AIG C03/AIG19005108/Exd302

Preliminary Advice

Vehicle No	: SLW9079B	Accident Date	: 16/03/2019
Make	: AUDI Q2	Policy No.	: 1800023129-01
Assignment Date	: 21/03/2019	Excess	: S\$800.00
Date of Inspection	: 20/03/2019	Est. Duration of Repair	: 25.00
Inspection At	: PREMIUM AUTOMOBILES PTE LTD (BENOI) 24 BENOI SECTOR SINGAPORE 629857

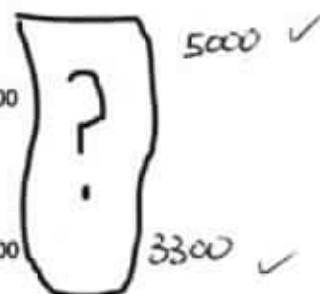
Labour 3 from re-inspection photo front did not even remove why allow for the labour. To take out.

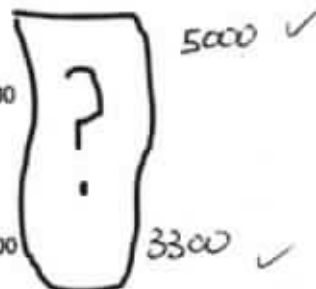
Labour 3 from re-inspection photo front did not even remove why allow for the labour. To take out.

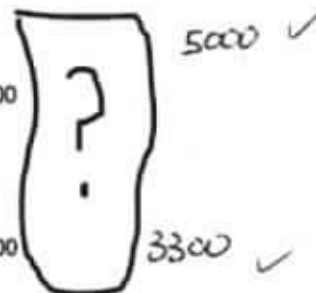
Labour 3 from re-inspection photo front did not even remove why allow for the labour. To take out.

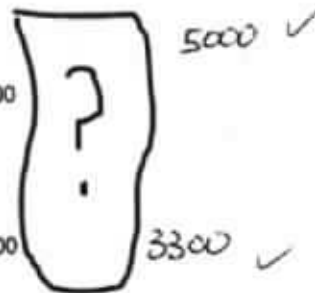
Labour 3 from re-inspection photo front did not even remove why allow for the labour. To take out. *photo 145*
